Access Compliance Report Public Rights-of-Way (Curb Ramps)

Main Street: BELLEFORD_RD Cross Street: WICKSHIRE_LN Location: S

ADA ID: RPRK220103135828 Ramp Type: Type 1 - Perpendicular Diagonal Initial Pass/Fail: Pass Overall Compliance: No Severity Score: 15

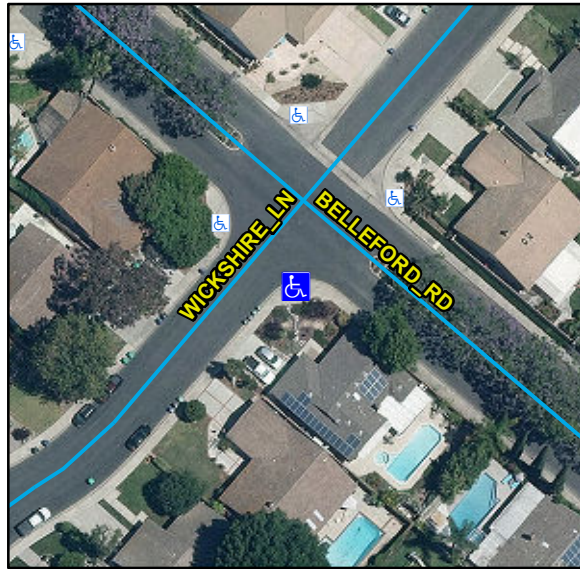
Compliance	Description	Data	Compliance	Description	Data
N/A	Ramp Length (in)	74	N/A	Flare Type LT	
Yes	Ramp Width (in)	48			Sloped
Yes	Ramp Run Slope (%)	3.3	Yes	Flare Slope LT (%)	7
Yes	Ramp Cross Slope (%)	0.2	N/A	Flare Traversable LT	Yes
N/A	Landing Present	Yes	N/A	Flare Type RT	
N/A	Landing Length (in)	48			Sloped
Yes	Landing Width (in)	48	Yes	Flare Slope RT (%)	5.5
Yes	Landing Run Slope (%)	1.7	N/A	Flare Traversable RT	Yes
Yes	Landing Cross Slope (%)	1.7	No	DWS Provided	No
N/A	Landing Movement Obstructed?	Yes	N/A	DWS Contrast	N/A
	Landing Movement Type	Curb	N/A	DWS Length (in)	N/A
N/A	Landing Shared	No	N/A	DWS Full Width	N/A
N/A	Clear Space	Yes	N/A	DWS Offset Left (in)	N/A
N/A	Clear Space To Crosswalk (in)	48	N/A	DWS Offset Right (in)	N/A
N/A	Marked Crosswalk 1	No	N/A	Marked Crosswalk 2	No
	Crossing 1 Direction	NE		Crossing 2 Direction	NW
	Marked Crosswalk 1 Width (in)	N/A		Marked Crosswalk 2 Width (in)	N/A

N/A	Ramp Inside Crosswalk 1	N/A	Yes	Ramp Inside Crosswalk 2	N/A
	Crossing 1 Slope (%)	4.4		Crossing 2 Slope (%)	5.3
	Crossing 1 Cross Slope (%)	1.7		Crossing 2 Cross Slope (%)	1.1
Yes	Gutter Ponding	No	Yes	Curb Slope	1.7
No	Gutter Lip Height (in)	0.25		Road Run Slope (%)	1.4
No	Gutter Run Slope (%)	6.9		Road Cross Slope (%)	4.9
Yes	Gutter Cross Slope (%)	1.1			
Yes	Overall Surface Condition: Acceptable		Yes	Perp Joint Present	Yes
	Cross Gutter Present?	No		Spandrel Present?	No
	Replace Cross Gutter?	N/A		Replace Spandrel?	N/A

Remove & Replace Curb Ramp With Two New Directional Ramps or Equivalent. Remove & Replace Gutter.
